AMENDMENT OF SOLICITATION/MODIFICATION OF CONTRACT				1. CONTRACT ID CODE *****	PAGE OF PAGES 1   3
2. AMENDMENT/MODIFICATION NO. 0003		3. EFFECTIVE DATE 04 JAN 21	4. REQUISITION/PURCHASE REQ. NO. 98110 /33219031	5. PROJECT NO. (If applicable)	
6. ISSUED BY NSWC CARDEROCK DIVISION 5001 S. BROAD STREET, CODE 335 PHILADELPHIA PA 19112-1403 BUYER/SYMBOL: LINDA STIEMKE PHONE NO. 215-897-1355		CODE N65540	7. ADMINISTERED BY (If other than item 6) CODE		
8. NAME AND ADDRESS OF CONTRACTOR (No., street, county, State and ZIP Code)			(X)	9A. AMENDMENT OF SOLICITATION NO. N65540-04-Q-0052	
			X	9B. DATED (SEE ITEM 11) 03 DEC 19	
				10A. MODIFICATION OF CONTRACT/ORDER NO.	
				10B. DATED (SEE ITEM 13)	
CODE		FACILITY CODE

## **15KV SWITCHBOARD WITH CIRCUIT BREAKERS SPECIFICATION**

**Figure 1. 15 kV Switchboard Electrical One-Line Diagram.**

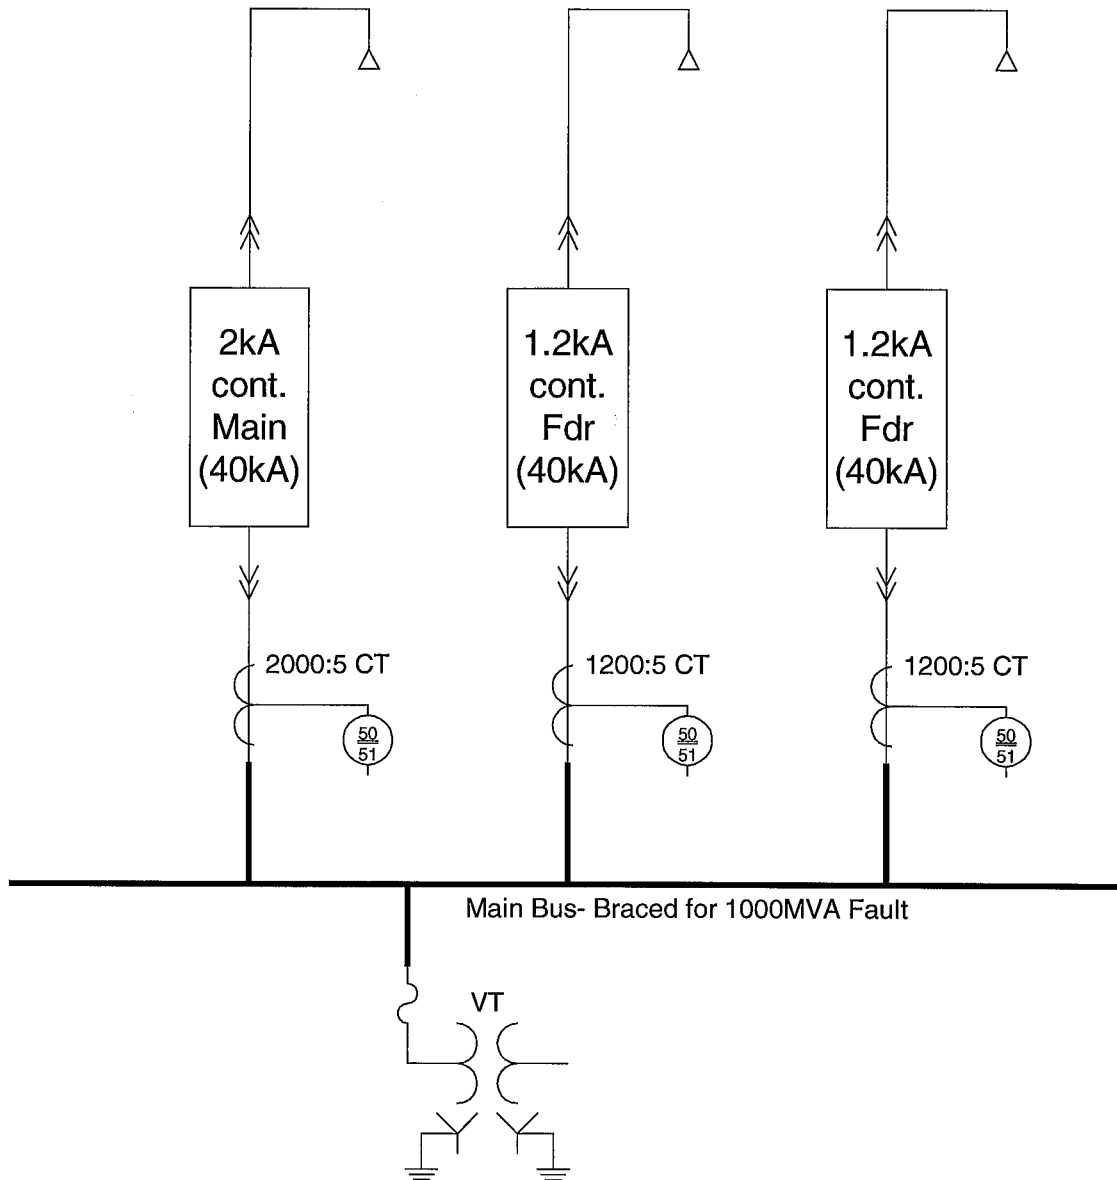
1) **Question:** No single line drawing was supplied.

**Answer:** A one-line diagram for the 15kV Switchboard is provided as Attachment 2 to this amendment for informational purposes only.
